BUILDING SUPPLY OF KANSAS CITY

Basswood - Farmhouse 3Car

ROOF TRUSS PLACEMENT
DIAGRAM

SHOP DRAWINGS/SUBMITTAL REVIEW

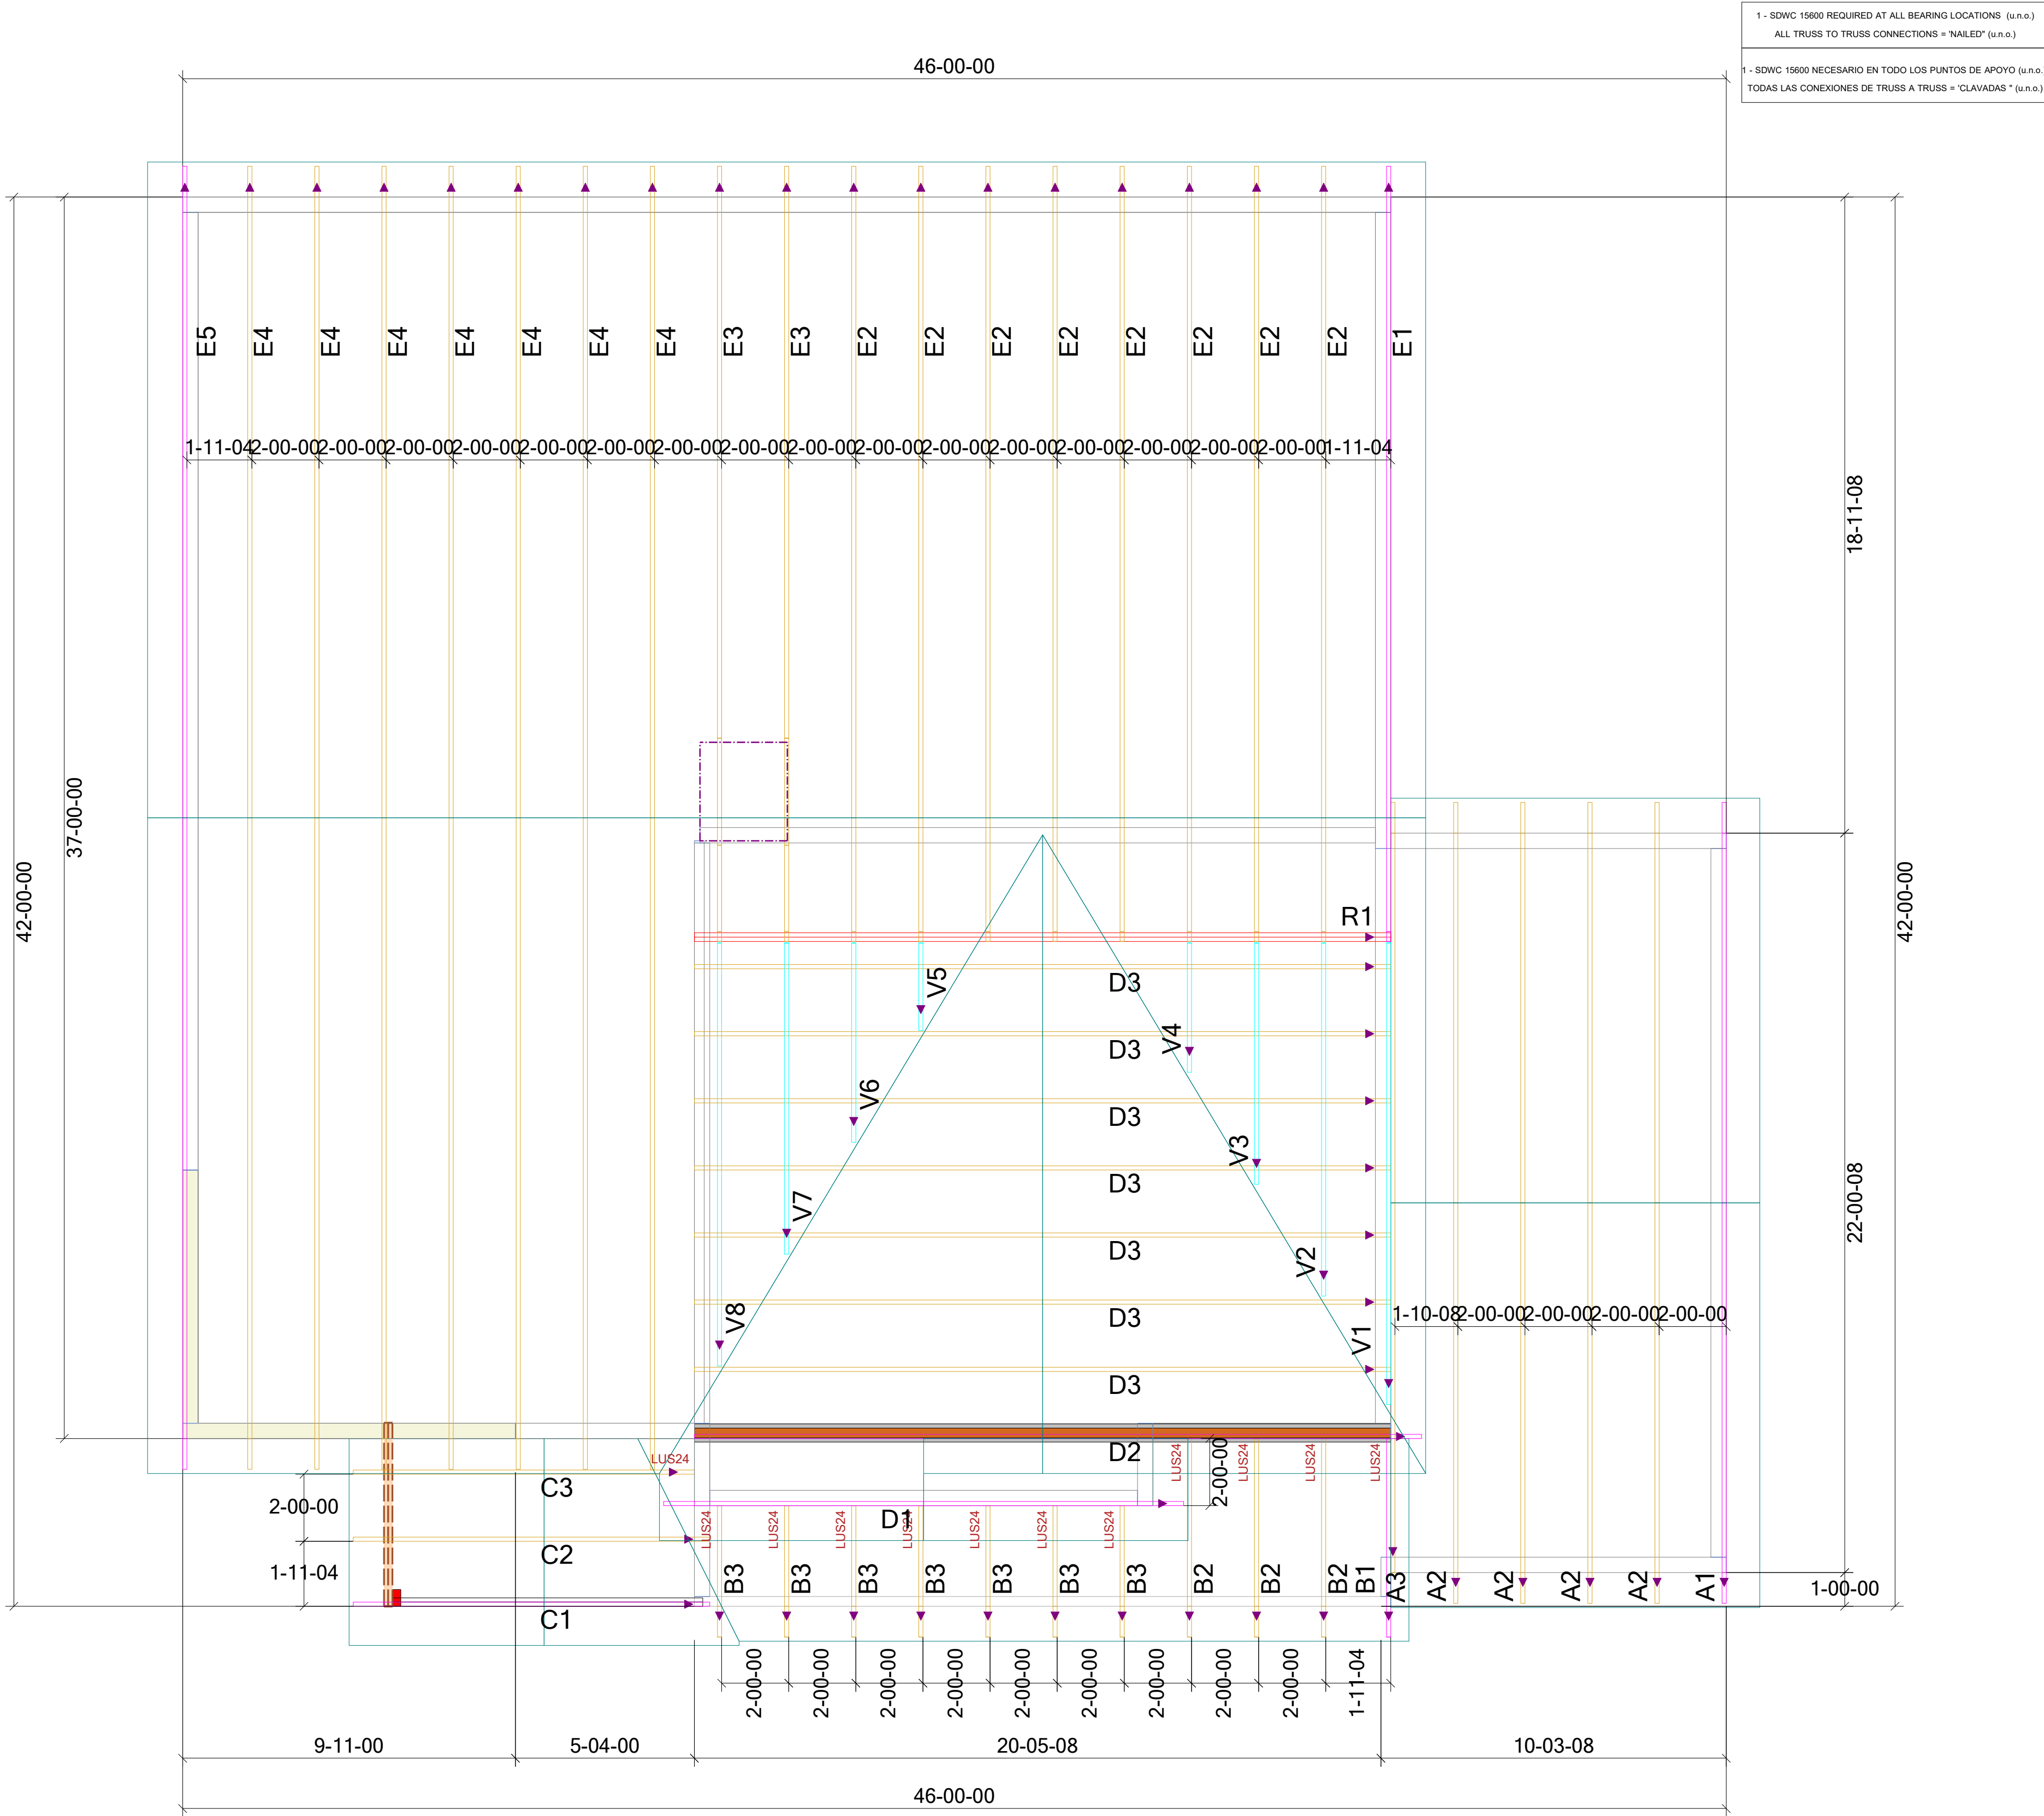
APPROVED
